REVISED RESPONSE TO REQUEST FOR ADDITIONAL INFORMATION

APR1400 Design Certification

RAI No.: 132-8088

SRP Section: 11.05 - Process and Effluent Radiological Monitoring Instrumentation and Sampling System

Figure 11.5-3B Typical Liquid Monitor

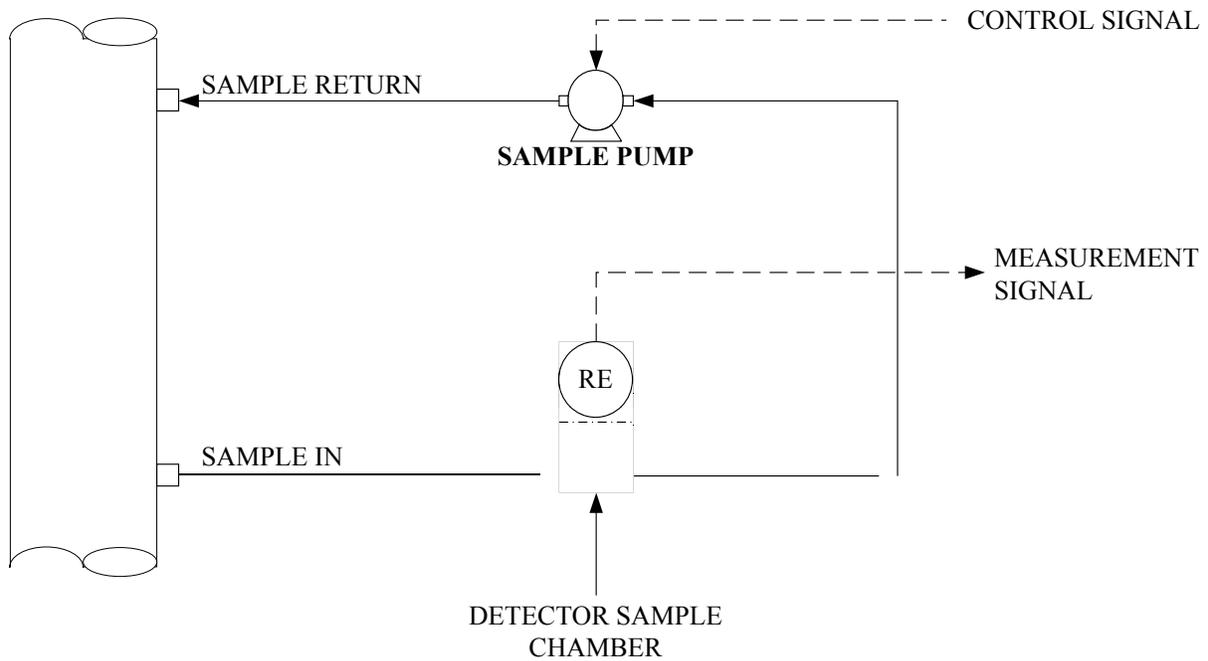
Subsection 11.5.2.3.1 and Figure 11.5-3B will be added to describe the process configuration of the liquid PERMSS.

Generic process configuration for the liquid PERMSS is shown in Figure 11.5-3B.

1. Depending on the temperature of the liquid sample, a sample cooler may be placed upstream of the detector chamber with cooling water supplied from the plant component cooling water.
2. The detector type of the liquid monitor is typically gamma scintillation detector.
3. The liquid monitor local skid is typically provided with demineralized water supply purge provision.
